From: [Puco ContactOPSB](#)
To: [Puco Docketing](#)
Cc: [Fischer, Mary](#); [Williams, Michael](#); [Agranoff, Jay](#)
Subject: comments for #18-1607-EL-BGN
Date: Monday, August 24, 2020 4:21:34 PM

OPSB Virtual Hearing for Emerson Creek Wind Farm

Summary: Public Comment of Gail L. Moyer, via website, electronically filed by Docketing Staff on behalf of Docketing

Figure 8: Cumulative Viewshed Analysis

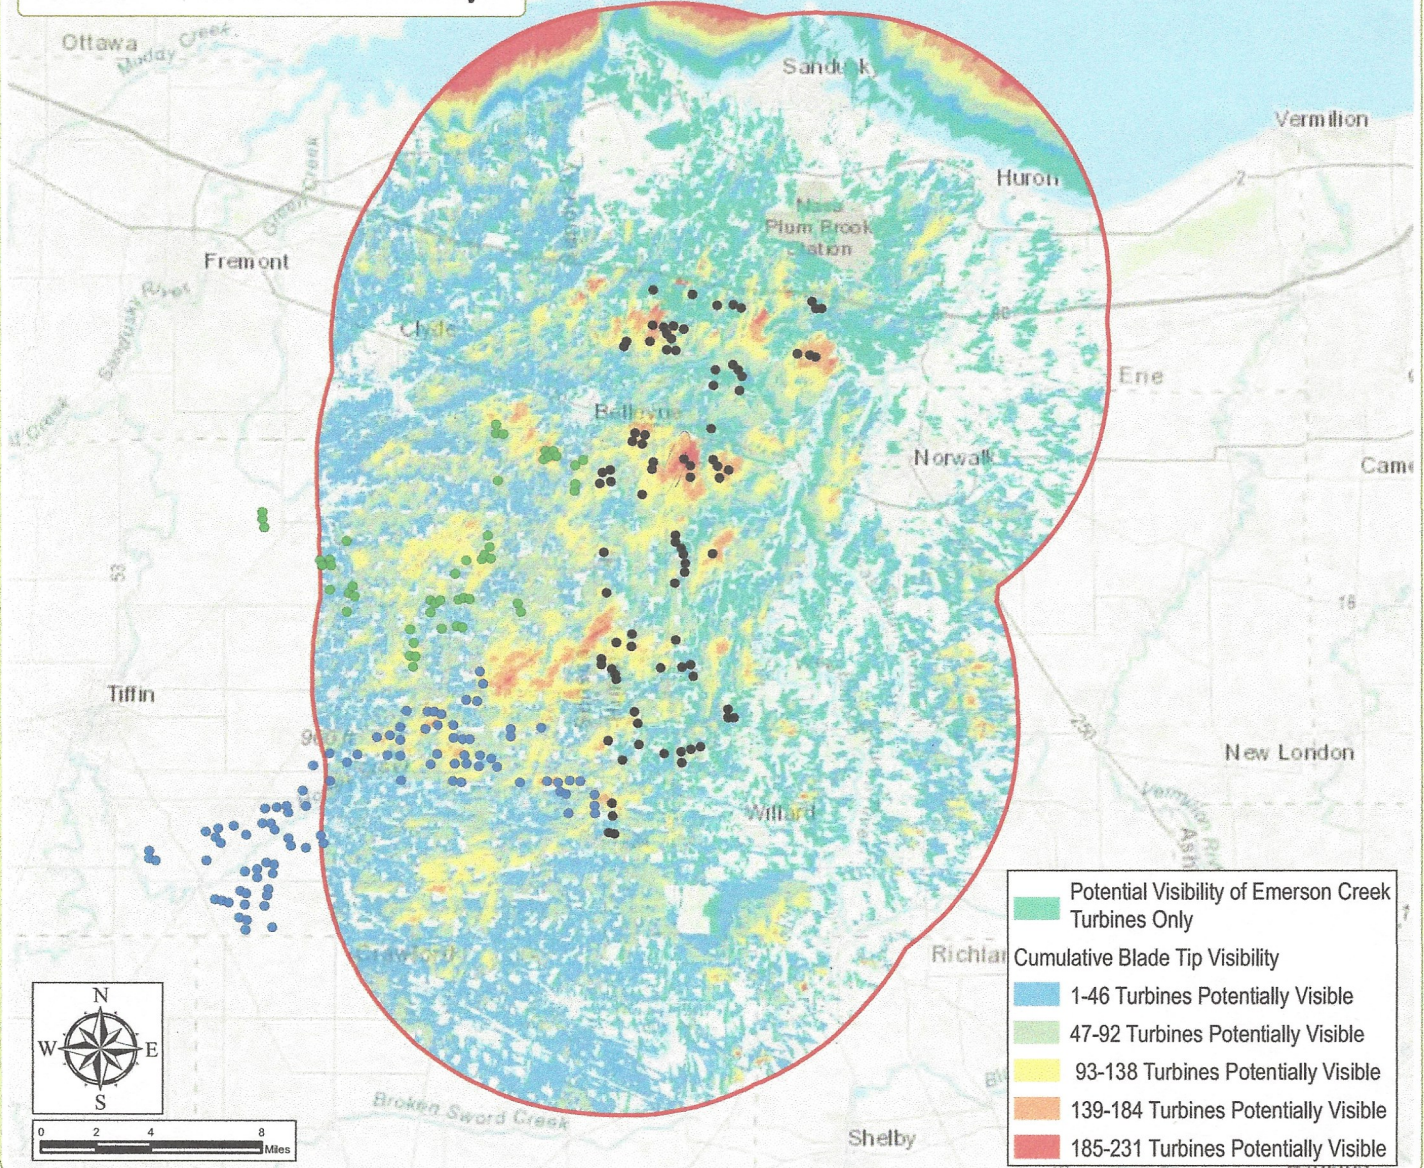
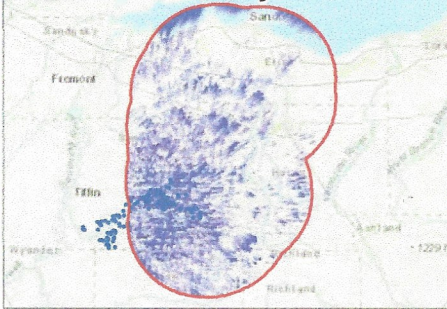
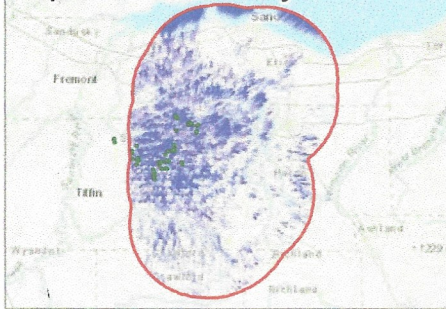
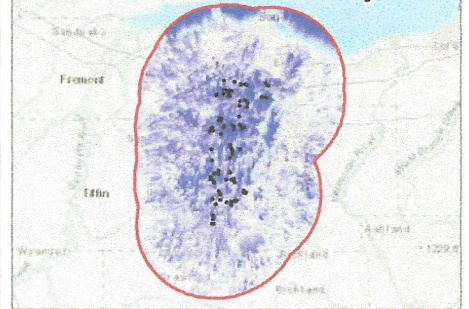
Ohio Administrative Code 4906-4-08 (D) (4) Impact of the facility, Section (a) states: "Describe the visibility of the project, including a viewshed analysis and area of visual effect shown on a corresponding map of the study area." In the submitted document, Section 5.1.1 Viewshed analysis states: "The topographic viewshed analysis indicates that areas where there is no possibility of seeing the Project based on screening by topography alone are extremely limited."

This is verified in Figure ^{*}8: "Cumulative Turbine Count Viewshed Analysis. I will be attaching this to a copy of my testimony and sending it to the OPSB via email. On this figure, there are at least **four** areas in the proposed Emerson Creek Wind Farm where **185-231** turbines are potentially visible. There are an additional **11** areas in the proposed Emerson Creek Wind Farm where **149-184** turbines are potentially visible, at least **15** areas where **93-138** turbines will be visible, and in the 10 mile visual study area, the vast majority of the area will see up to **92** turbines.
